HOMESTEAD NORTH AT STERLING RANCH FILING NO.1

STREET IMPROVEMENT PLAN

HOMESTEAD NORTH AT STERLING RANCH FILING NO. 1
COUNTY OF EL PASO, STATE OF COLORADO
JUNE 2022
STORM SEWER PLANS

SIGNAGE

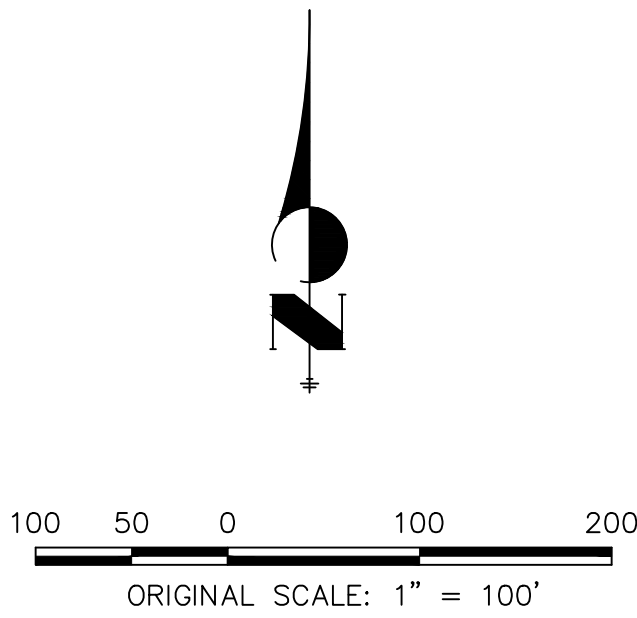
Adjust size of symbols, add street names

SHEET 3 OF 16

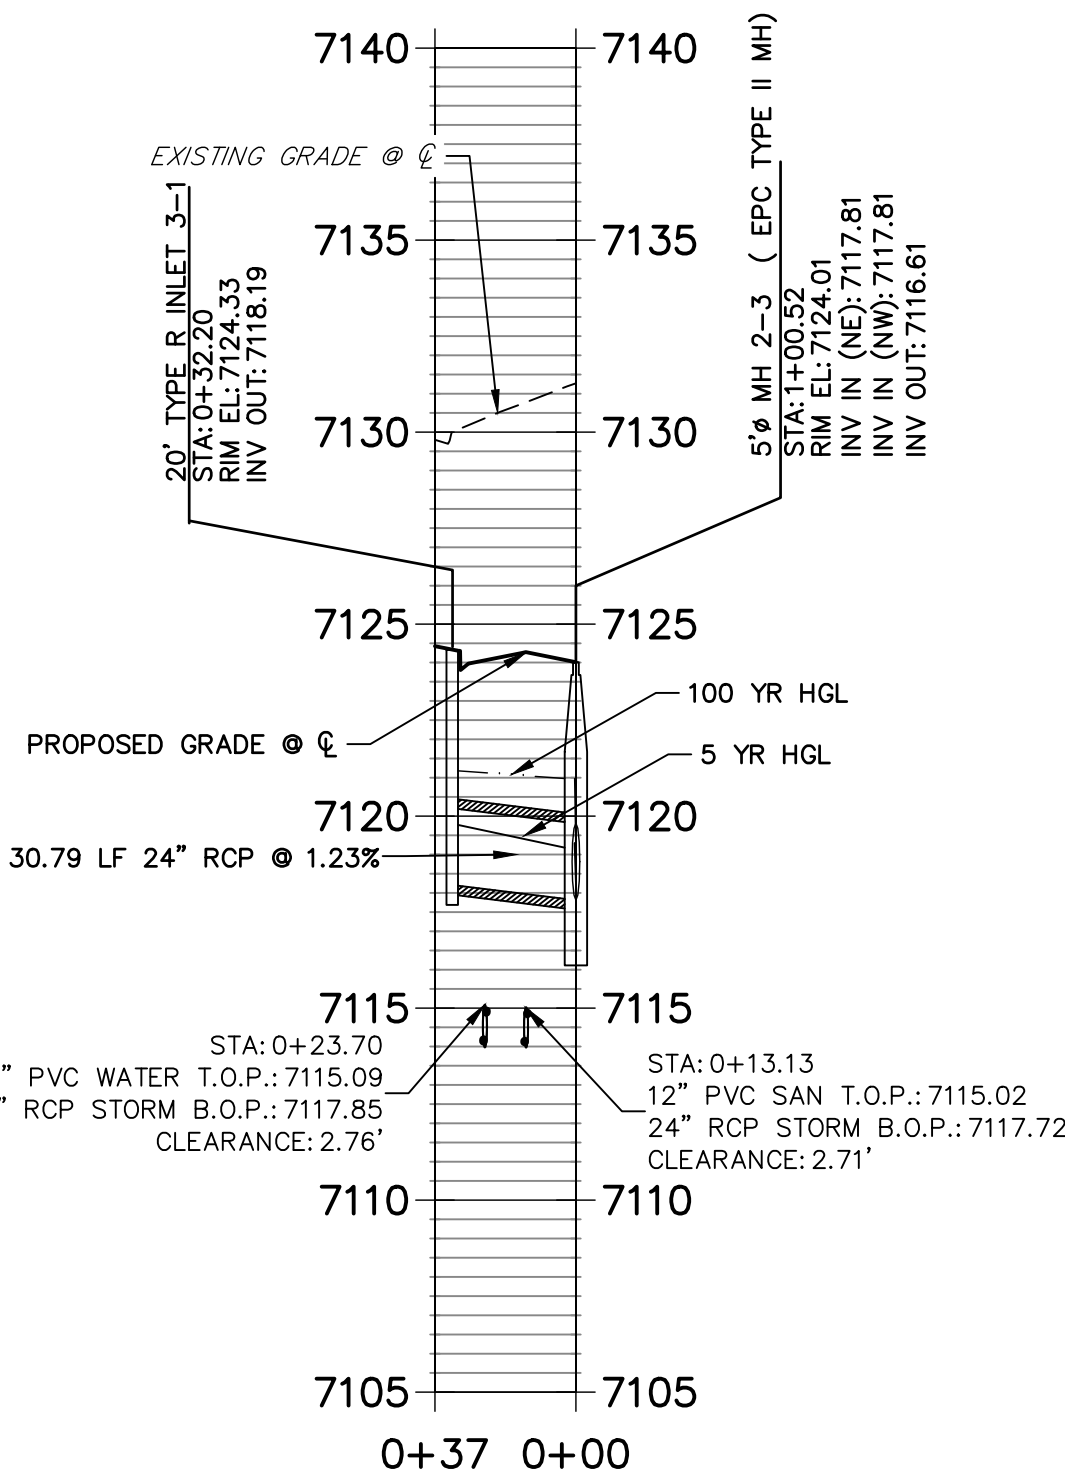
Replace contours
on all P&P sheets

DP05 PROFILE
STA 0+00.00 TO 0+13.67

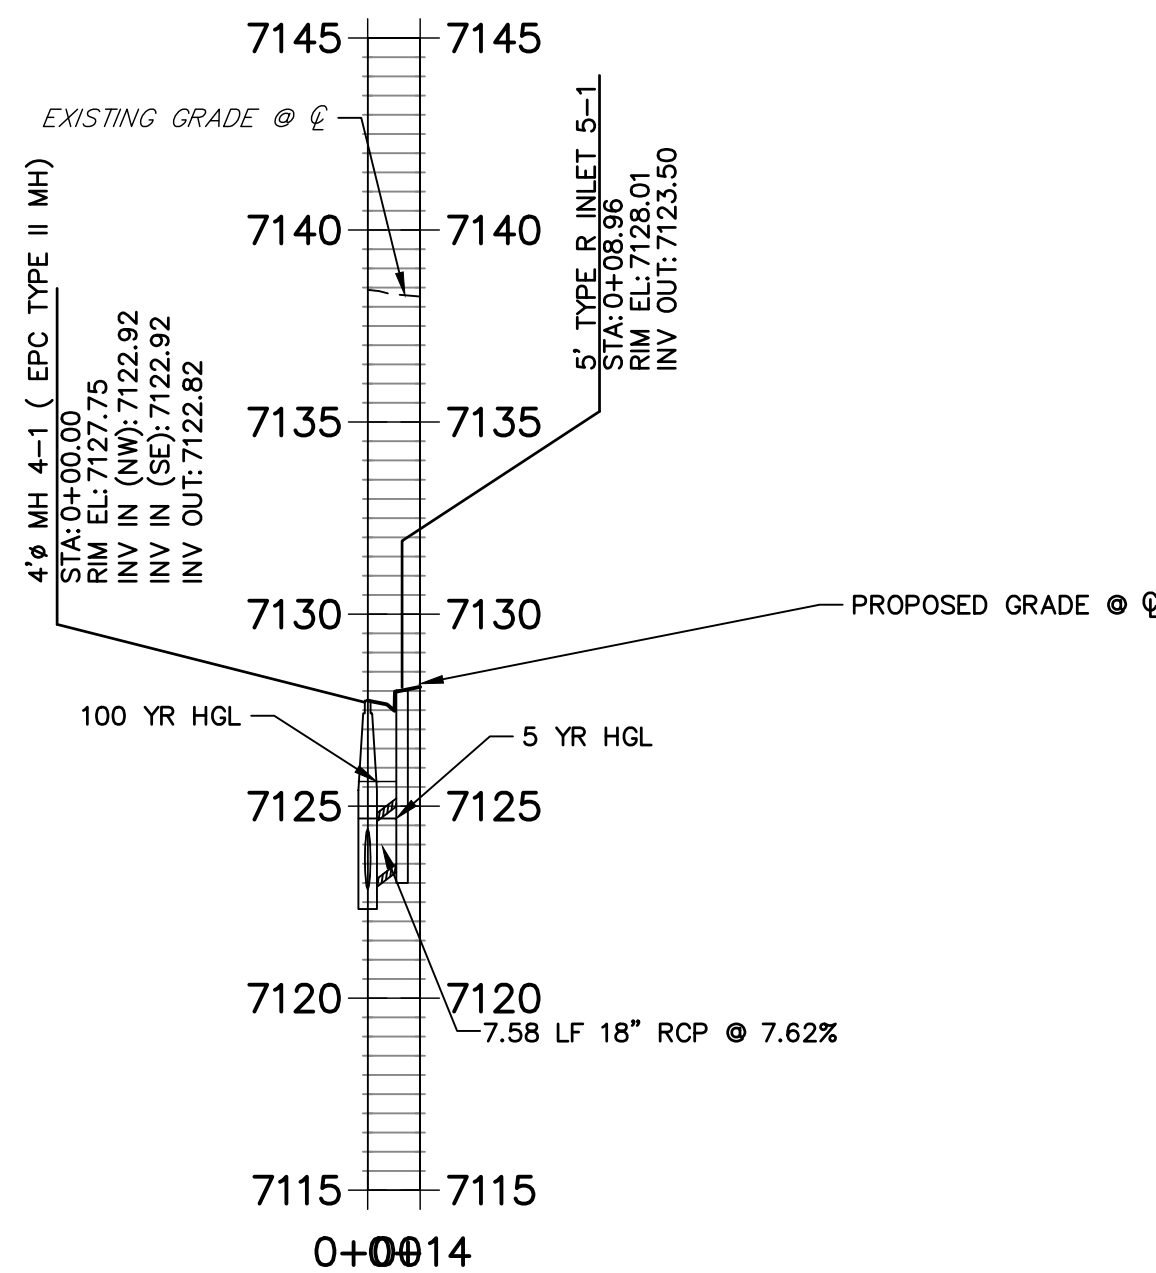
Watertight pipe
joints required -
add note

DT01 FOREBAY 2 MAIN
BAFFLE BLOCK PLAN
SCALE: 3/8"=1'

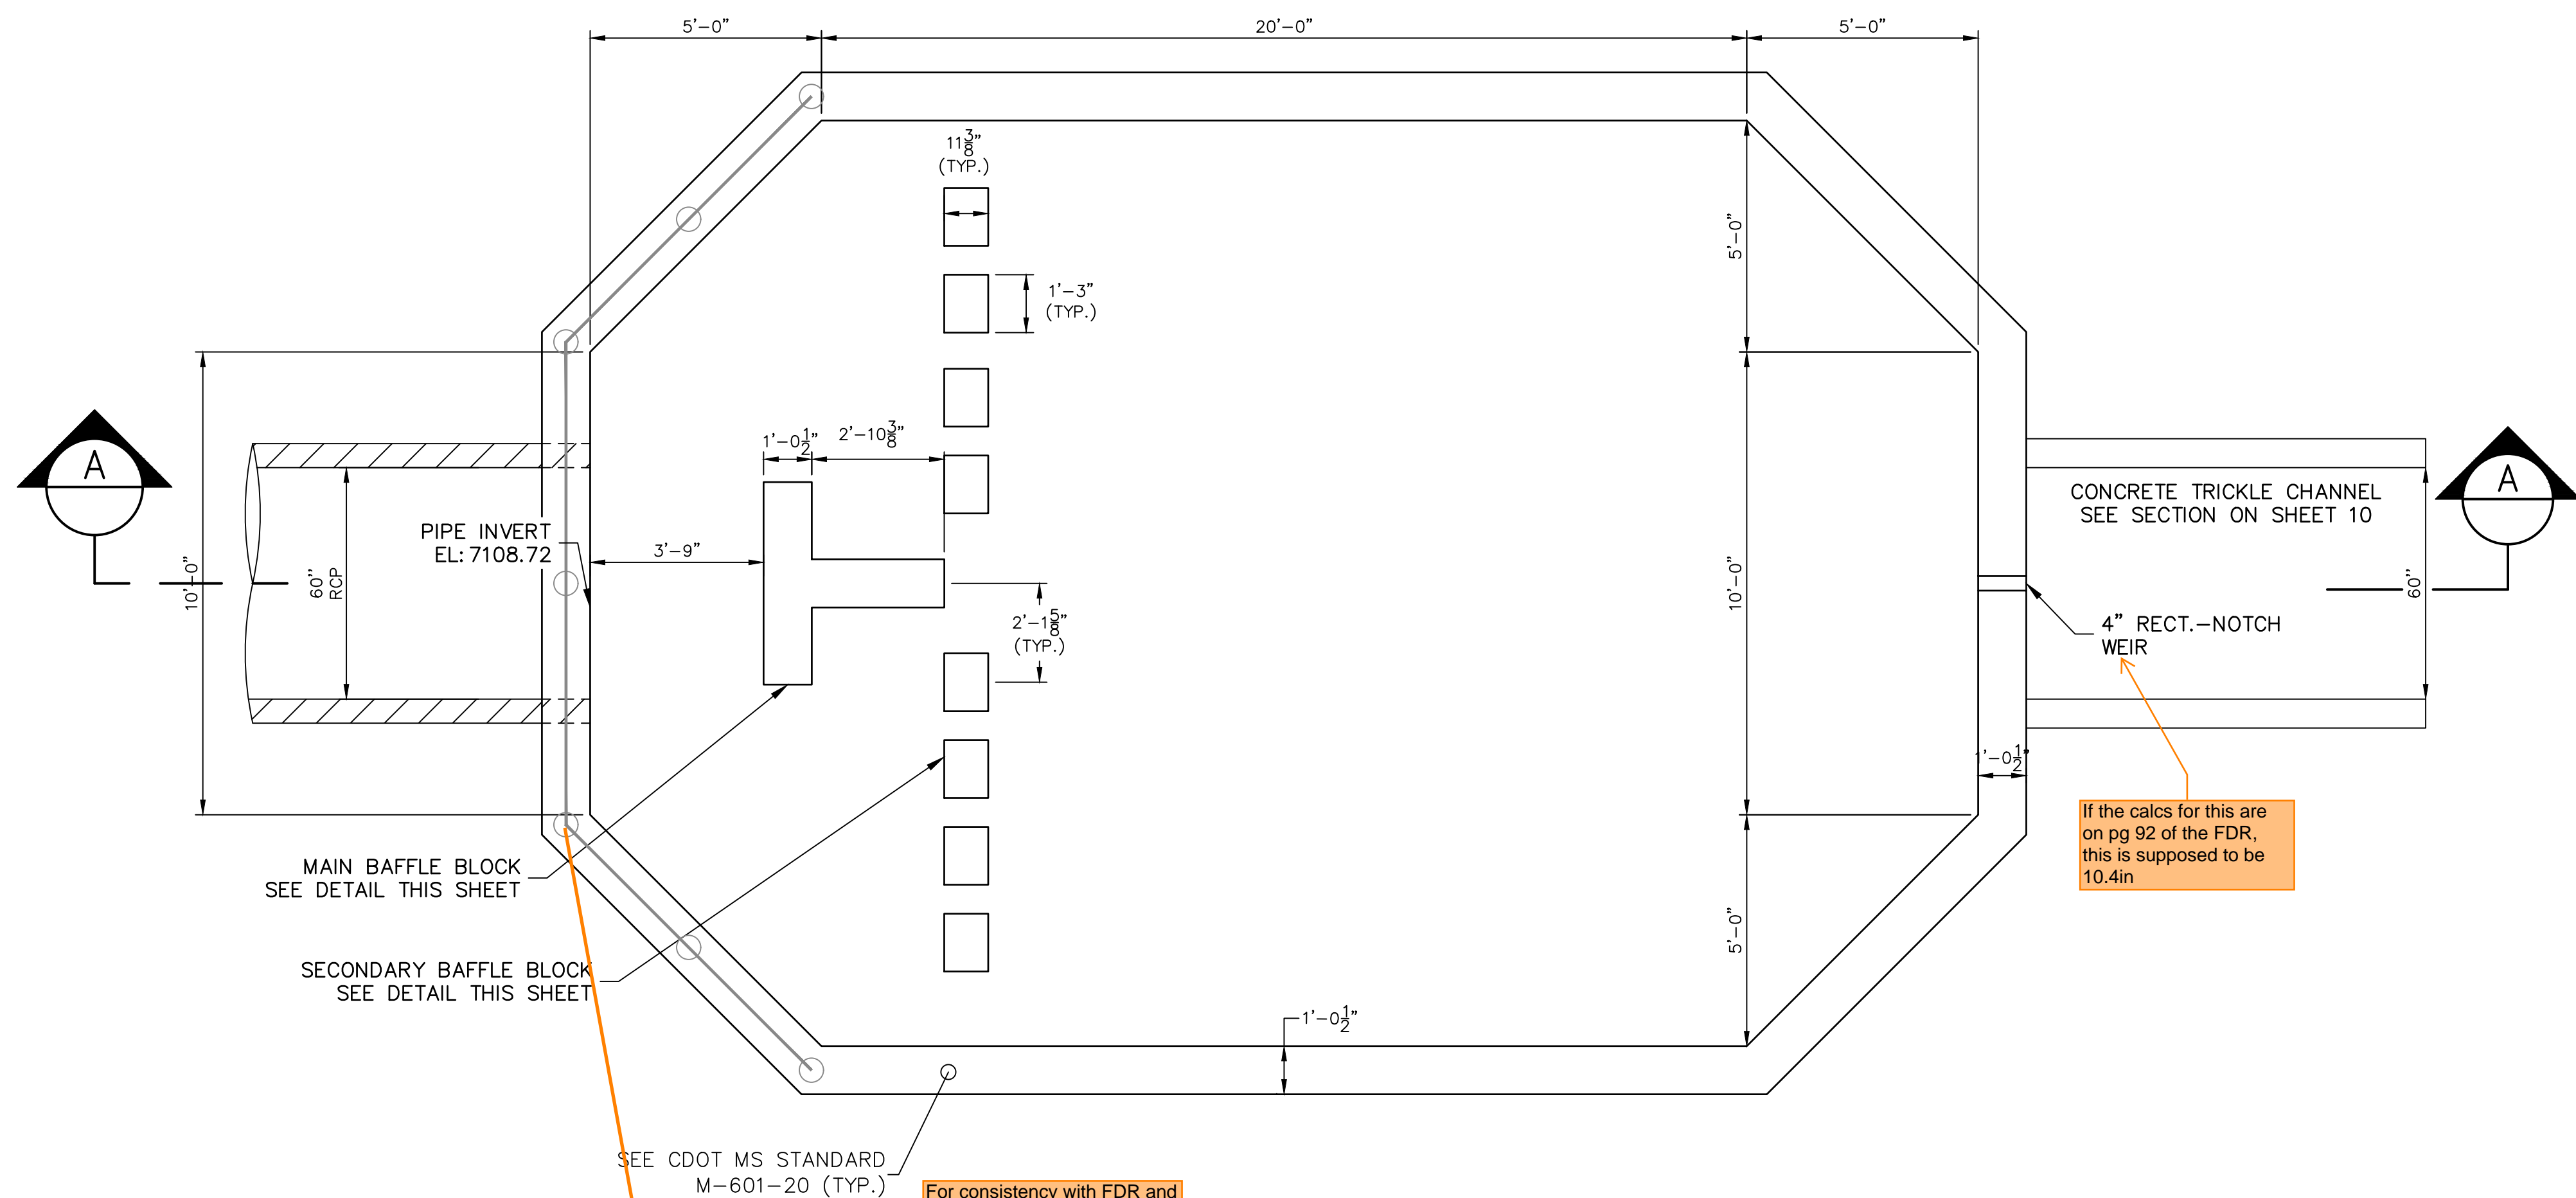
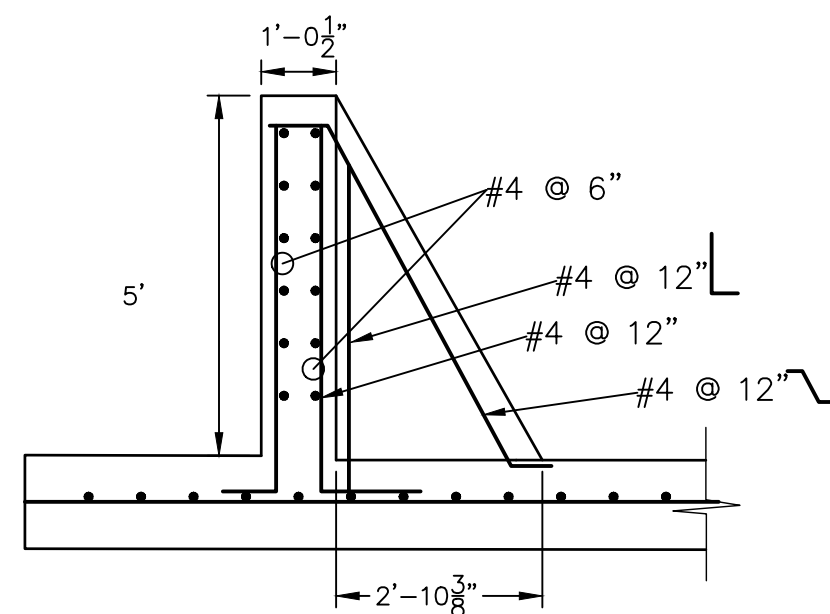
Can you line up the plan and section in a straight vertical line so it is clear how they correspond?

For consistency with FDR and GEC Plan, please call this Pond C on all sheets of CDs.
